Forest Glen Road Sidewalk Project - Project Design

Key Design Issues:

Design Objects Inappropriately Prioritized and/or Lack Full Roadway User Scope Consideration

Forest Glen Road Sidewalk Project: Forest Grove Dr to Admiralty Dr

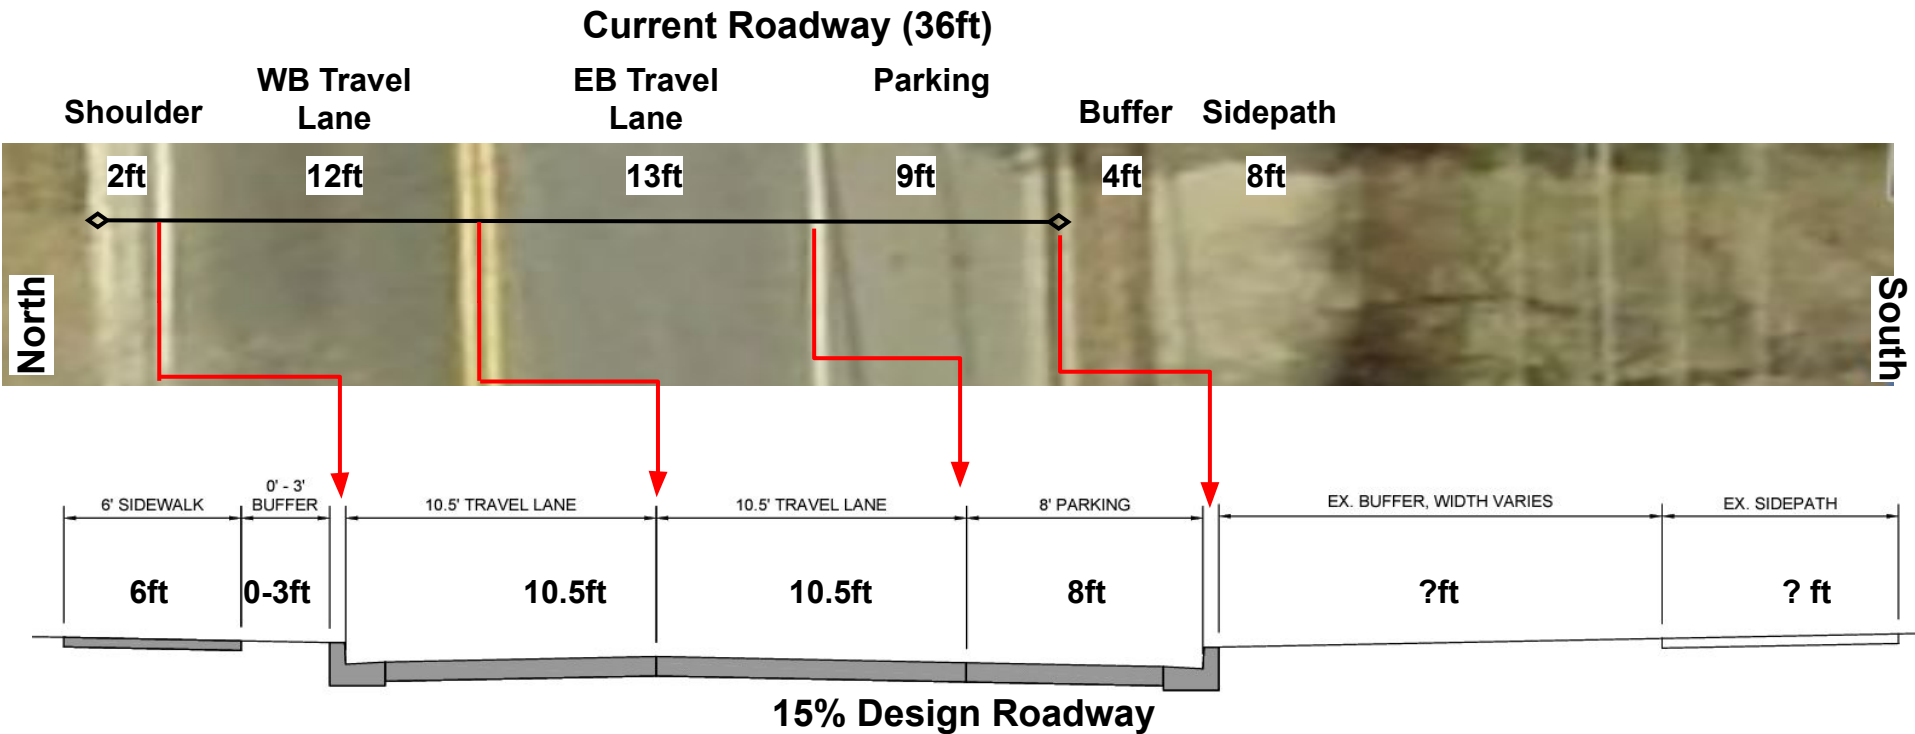
Forest Glen Road Sidewalk Project: Forest Grove Dr to Admiralty Dr Take the WB Shoulder (aka Bike Lane)... Keep Parking?

To build the northside 6ft sidewalk and provide a 0-3ft buffer, the curb is moved 6-9ft southward. Travel lane width is reduced to 10.5ft. 2ft WB buffer is removed. Southside parking width is reduced from 10ft to 8ft.

- With no buffer, westbound bicyclists will be forced into WB travel lane slowing traffic for long distances. Drivers will get frustrated and attempt to pass bicyclists crossing the double yellow line. This will be a risky movement in moderate traffic risking a head-on crash or an aborted “pull-in” hitting or cutting off the bicyclist.
- 9ft southside parking serves as a narrow space for EB bicyclists to travel (although in the “door zone”). Narrowing parking and travel lanes will force EB bicyclists into EB travel lanes increasing driver-bicyclist conflicts.
- Bicyclists may attempt to use the south sidepath but crowded conditions will cause conflicts with pedestrians walking to/from Holy Cross Hospital and Forest Glen Metro.

Recommendation: Remove southside Parking; add Bike Lanes and northside Sidewalk and limited Street Buffer; narrow southside Street Buffer from 4ft to 2ft.

Forest Glen Road Sidewalk Project: Admiralty Dr to Saxony Rd

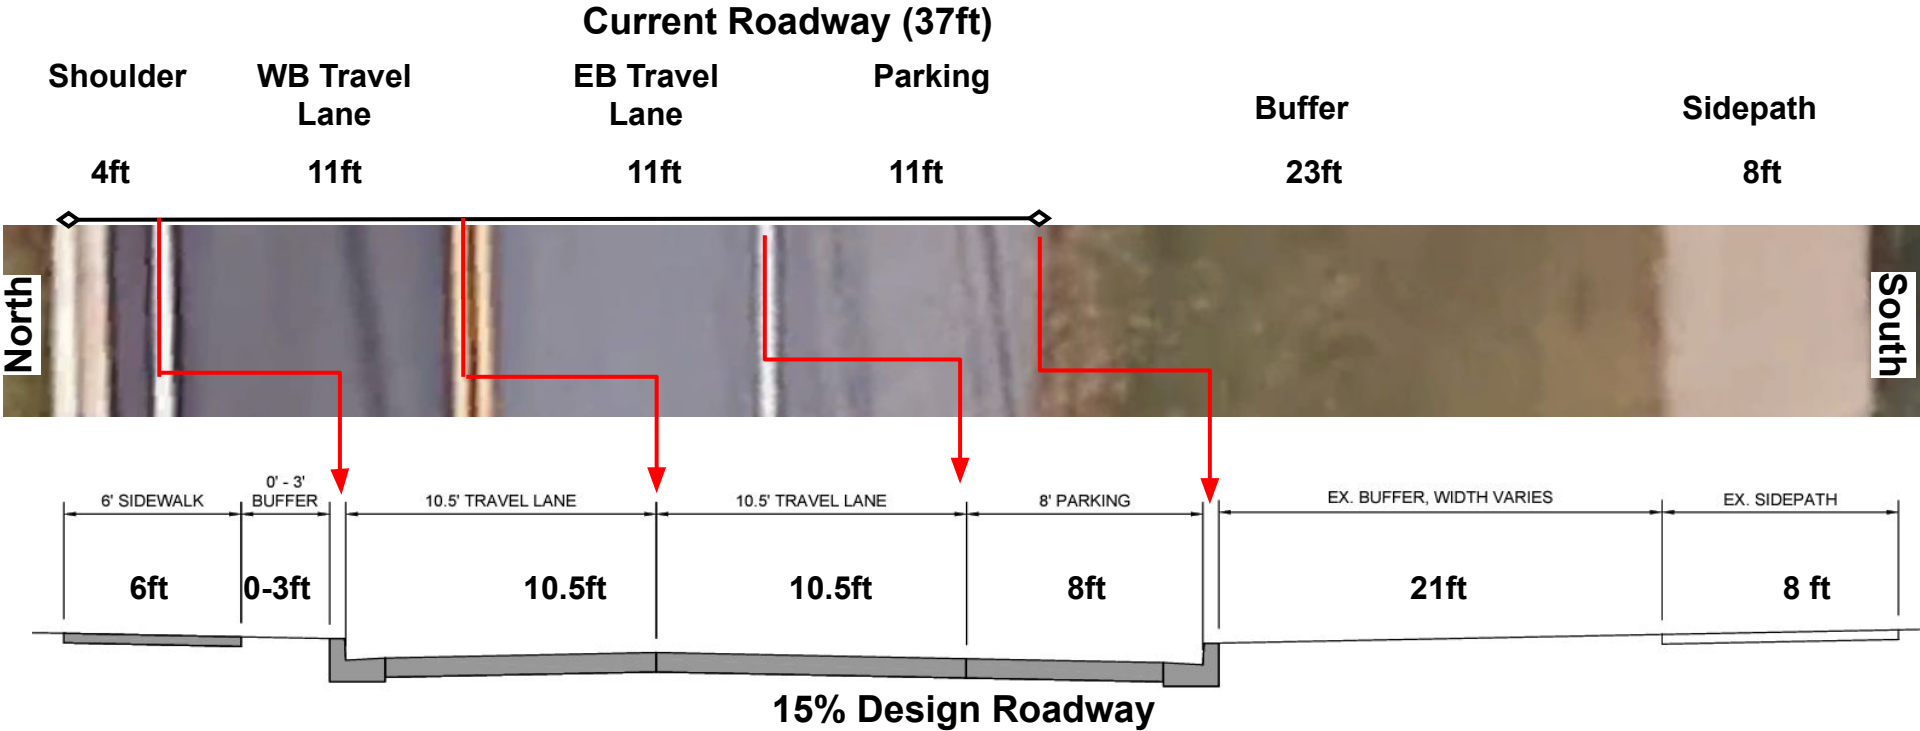
Take the WB Shoulder (aka Bike Lane)... Keep Parking?

To build the northside 6ft sidewalk and provide a 0-3ft buffer, the curb is moved 6-9ft southward. Travel lane width is reduced to 10.5ft. 3ft WB buffer is removed. Southside parking width is reduced from 10ft to 8ft. Southside curb moved 9-12ft southward.

- With no buffer, westbound bicyclists will be forced into WB travel lane slowing traffic for long distances. Drivers will get frustrated and attempt to pass bicyclists crossing the double yellow line. This will be a risky movement in moderate traffic risking a head-on crash or an aborted “pull-in” hitting or cutting off the bicyclist.
- 11ft parking serves as a narrow space for EB bicyclists to travel (although in the “door zone”). Narrowing parking and travel lanes will force EB bicyclists into EB travel lanes increasing driver-bicyclist conflicts. Bicyclists may attempt to use the south sidepath but crowded conditions will cause conflicts with pedestrians walking to/from Holy Cross Hospital.

Recommendation: Remove southside Parking and northside shoulder; add Bike Lanes and northside Sidewalk, if northside Road Buffer is needed, move roadway southward reducing 22ft southside street buffer to 19ft street buffer (which will not be expensive since there is not currently a curb on the southside).

Streetscape Changes: Current to **Project Design**

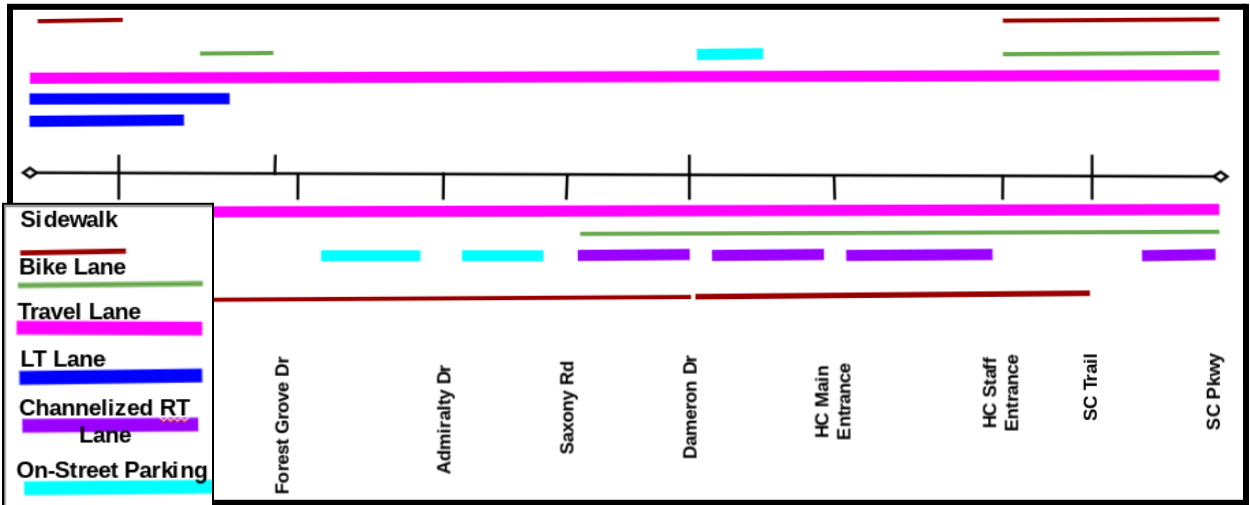
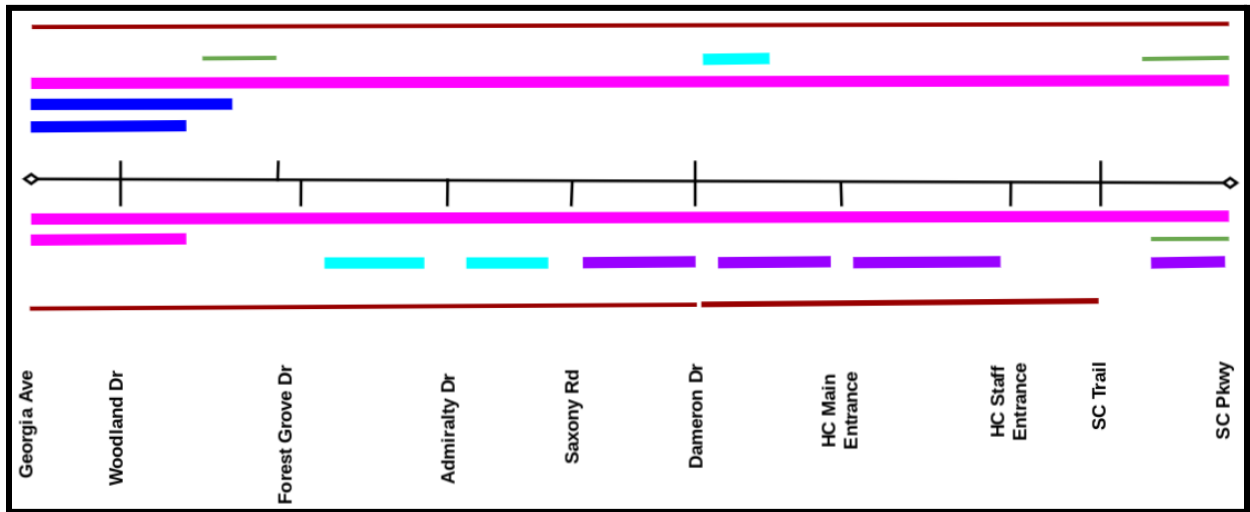
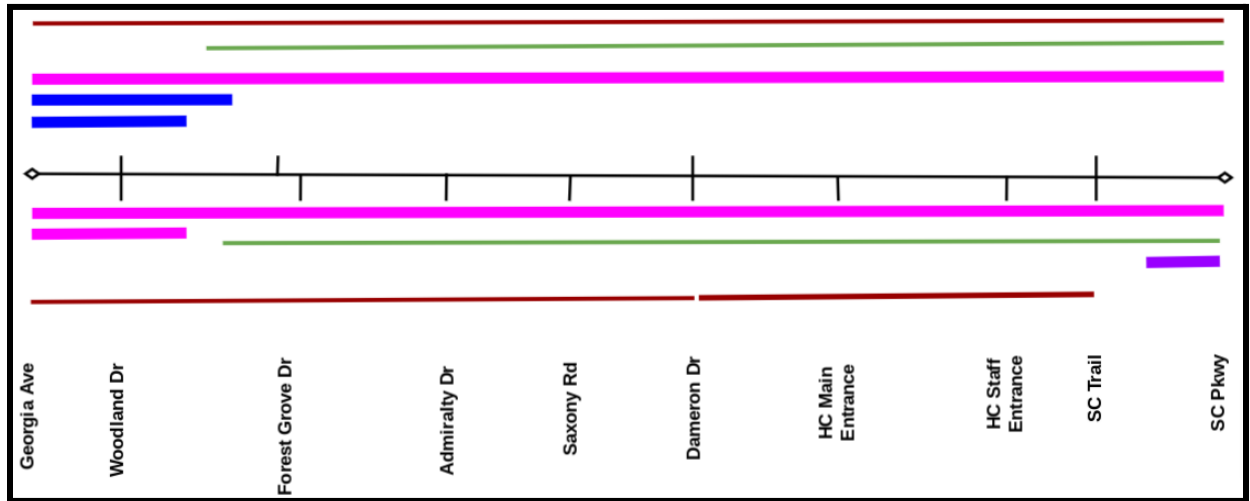
- The Project design removes almost 2,000 ft of Bike Lanes which were built over 10 years ago.
- These Bike Lanes provide primary local connectivity to Forest Glen Metro and regionally between Sligo Creek Trail/Parkway to Rock Creek Trail/Beech Drive

- Design prioritizes 475ft of on-street parking and 1,000ft of channelized right turn lanes, apparently to optimize free-flowing through traffic, over bicyclist and pedestrian safety.

In re-allocating roadway right of way space to add the northside sidewalk, the project design should follow Complete Streets Design Guide by prioritizing bike lanes over on-street parking and channelized right turn lanes.
